**UNITED STATES NUCLEAR  
REGULATORY COMMISSION  
WASHINGTON D.C.**

## Integrations to our previous application

List of the requested answers according to the points mentioned in your enclosure dated 22<sup>nd</sup>. April 2003. The whole revised application will be following per courier.

**APPLICATION FOR REGISTRATION  
OF RADIATION DEVICE MODEL ISOSINT  
FOR RADIOACTIVE SOURCES Kr. 85 AND Sr. 90**

SURF.TREAT.						
THERM.TREAT.						
MATERIALS		MACHINE SCANNER - SINTEL9000				
DES.	TM	DESCRIPTION <b>ISOSINT PLAN VIEW</b>				
CHECKED	TM					
APPROVED	TF					
HD ARCHIVE						
 <b>Electronic SYSTEMS</b> S.p.a.				SCALE	DATE	F.TO
				1:2	12.03.03	A4
			DWG.NO	<b>U.S. 1001</b>		REV.
						-

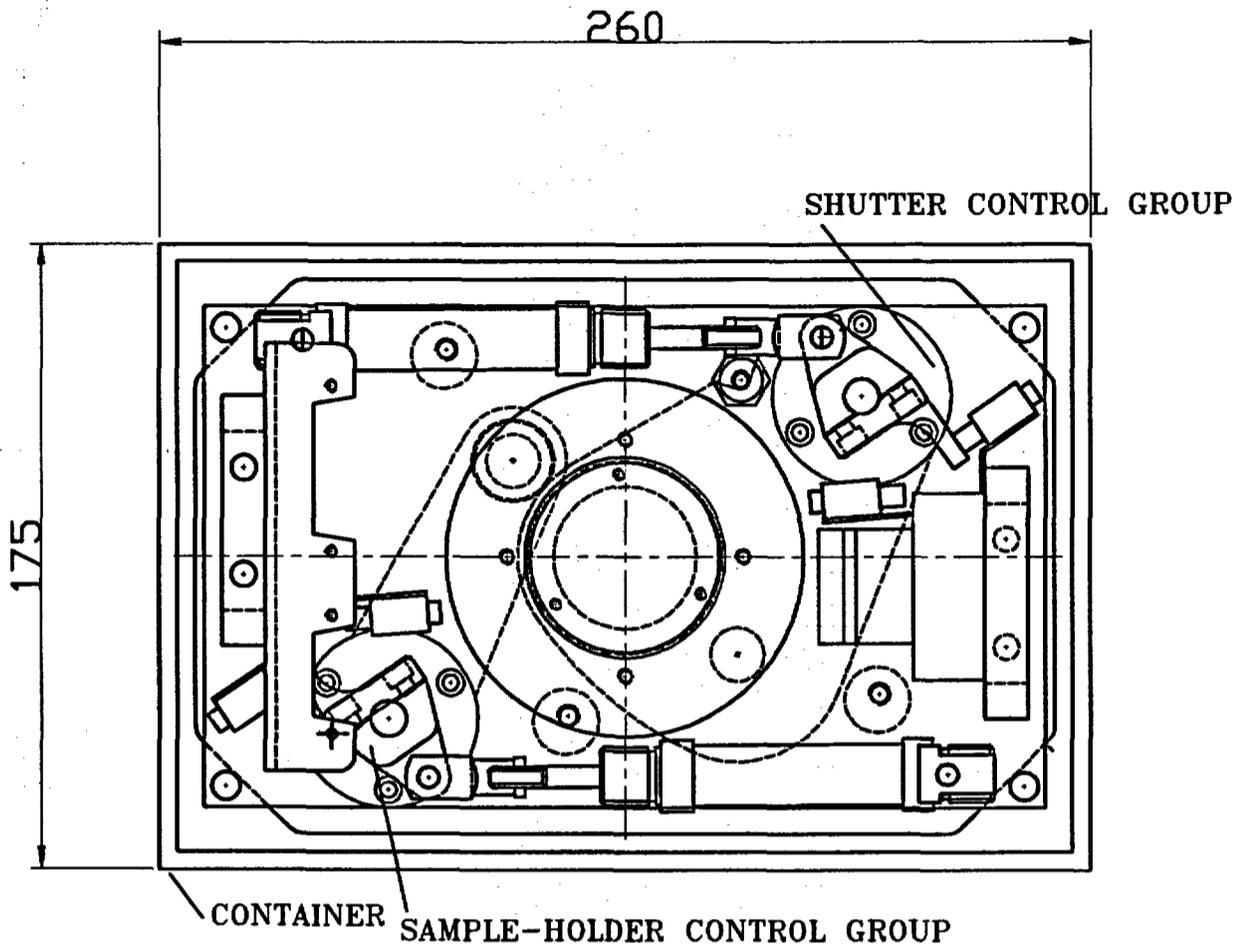
As requested we have revised engineering drawings **US 1001** and **US 1002** and indicated the overall dimensions of the gauge (see enclosure); we provide also the revised engineering drawing n. **US 1009** where we have eliminated the name *Slim duplex 1700* and modified with the right name **SINTEL 9000** according to the lists of enclosures (ref. Page 4 our application) (see enclosure); concerning the engineering drawing n. **US 1004** we have sent you a drawing for *Strontium 90* and not *Krypton 85*; in any case, we provide also the missing drawing **US 1004A**.

SURF.TREAT.				
THERM.TREAT.				
MATERIAL		MACHINE SCANNER - SINTEL9000		
DES.	TM	DESCRIPTION <b>ISOSINT EXPLODED VIEW FOR 90 Sr.</b>		
CHECKED	TM			
APPROVED	TF			
HD ARCHIVE				
 <b>Electronic SYSTEMS</b> S.p.a.		SCALE	DATE	F.TO
		DWG.NO DISEGNO	1:2	12.03.03
			<b>U.S. 1004</b>	REV. -

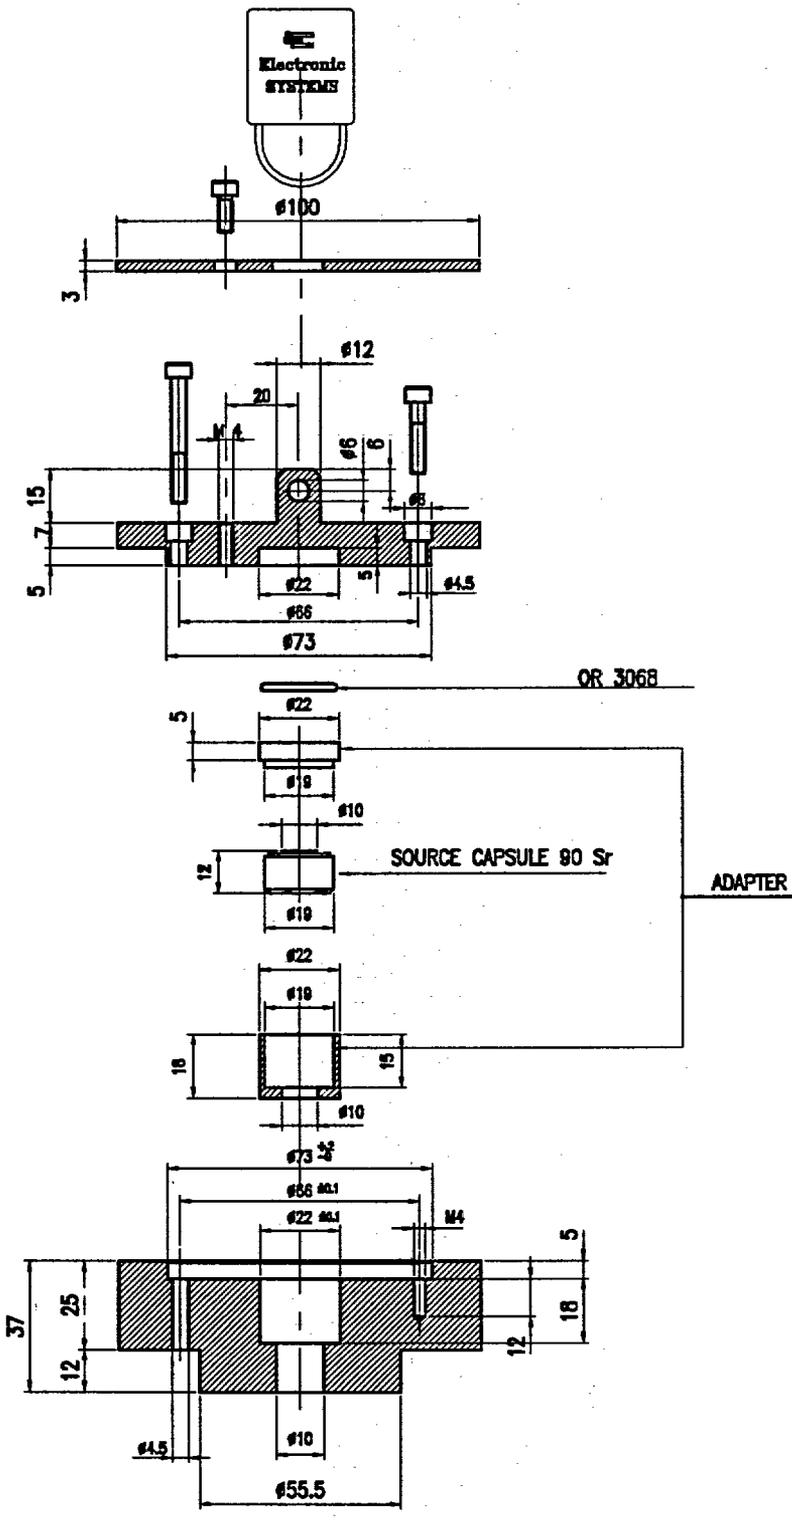
The safety lock is a simple stainless steel lock. The lock is clearly shown on DWG. **US 1004** (on top of the page). The safety lock avoids tampering of the source holder to be removed by unauthorized personnel. The shutter control group in open and closed positions are shown on **US 1005** (open) and **US 1006** (closed); set-point of the shutter control group is performed at *Electronic Systems S.p.A.* laboratory by rotating the safety locks (**US 1005 - US 1020**) so that the shutter will be opened and closed completely. The safety locks (**US 1005 - US 1020**) are then fixed in that right positions with screws at the base plate without any possibility to move or remove them from those positions. The ON-OFF switches are simple mechanical switches pressed by the mechanical component shown on drawing **US 1012**; the mechanical action is performed by the pneumatic cylinder with return spring (**US 1005**). There exist another control group similar to the one just described, used to move a little sample of material under the radioactive beam (when the shutter is in open position); the mechanical action is performed by a pneumatic cylinder with return spring; then, there are 2 ON-OFF switches to communicate the position of the sample at the control unit. The ON-OFF switches are pressed by the mechanical movement of the control lever (**US1012**).

<b>Electronic SYSTEMS S.p.A.</b>	DESCRIZIONE: <b>SINTEL 9000</b>	DATE: <b>12.03.03</b>	DES. <b>FS</b>
		SCALE: <b>1:15</b>	CHECKED: <b>FS</b>
			APPROVED: _____
			REV. _____
		DWG. N° <b>U.S. 1009</b>	DATE

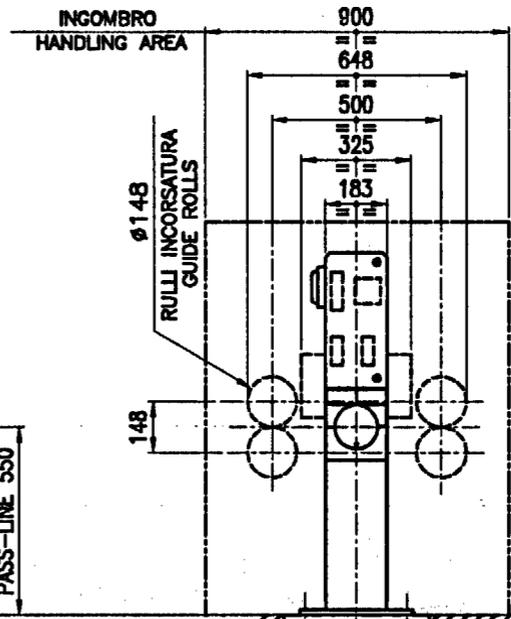
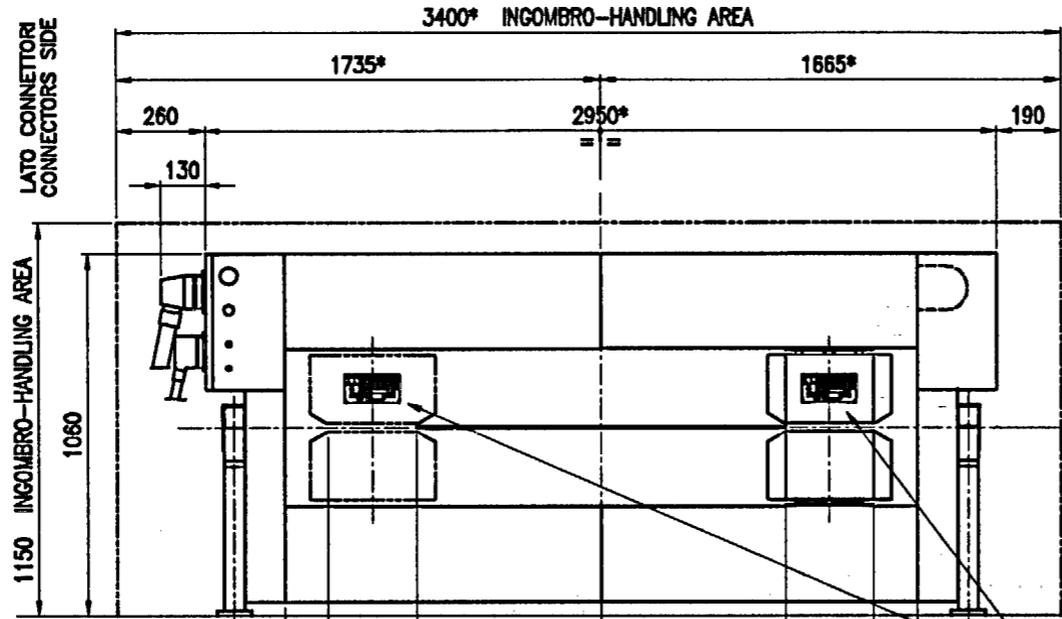
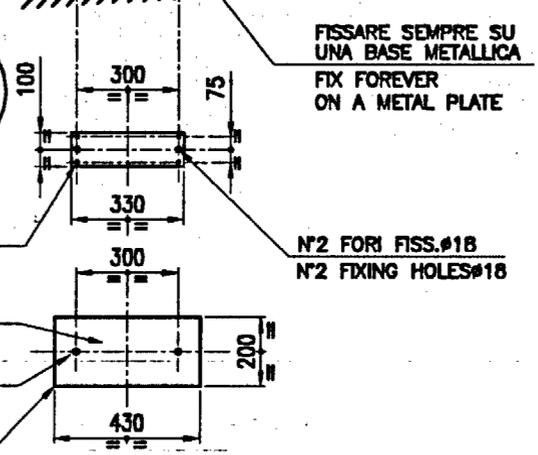
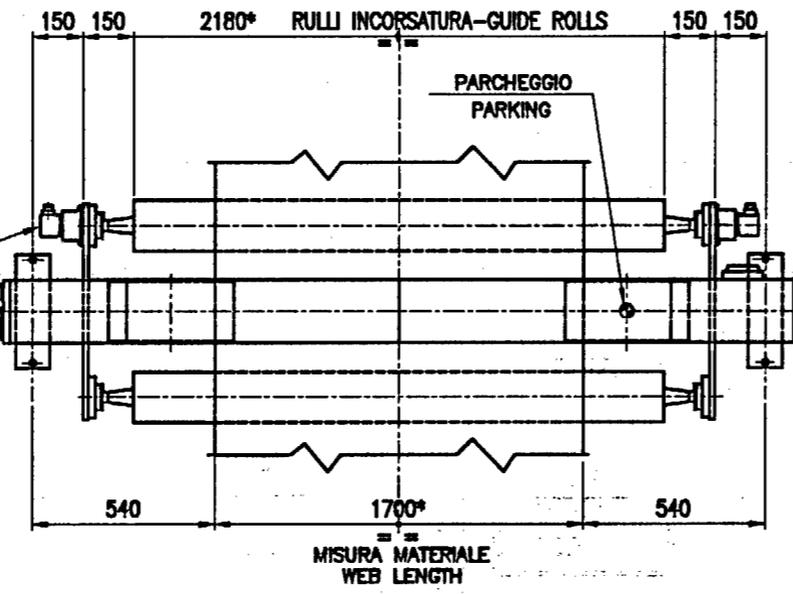
Please see Paragraph n. 3.3.3 page 22, where it is described how the label is attached (US 1036); as required see enclosed drawing with mechanical dimensions and materials. Concerning location please see drawing US 1009 where it is shown where the labels are placed on.
